Re: Case 20-E-0197 -- Proceeding on Motion of the Commission to Implement Transmission Planning Pursuant to the Accelerated Renewable Energy Growth and Community Benefit Act

The New York Offshore Wind Alliance (NYOWA) respectfully submits the following supplemental comments on the Brooklyn Clean Energy Hub ("CEH" or "Hub") concept submitted by Con Edison in the above-referenced matter. NYOWA filed extensive comments regarding the Hub on July 11, 2022. These comments are intended to address new information gleaned from the technical conference on August 17th convened by the New York State Energy Research and Development Authority and the Department of Public Service, information submitted by the company in response to stakeholder questions, and meetings with the utility to address developer concerns.

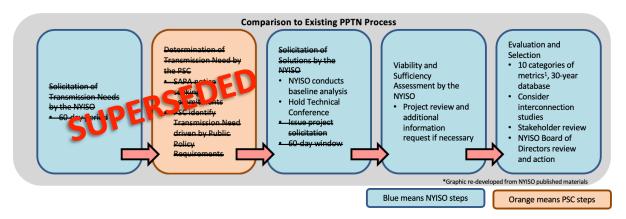
As depicted in the chart above, in lieu of releasing a more competitive solicitation, the Commission could request the NYISO – or retain an independent consultant – to apply a modified PPTN-style evaluation of the CEH. The evaluation would consist of two major elements - electrical and physical. With regard to the former, the consultant would conduct its own independent study to validate Con Edison's assumptions with a fact-based holistic approach (Generation + Transmission) for total New York ratepayer costs. The consultant can benchmark Con Edison's assumptions against independently determined values to quantify ratepayer savings, as well as any implications to local employment and property tax-base leakage to neighboring states.
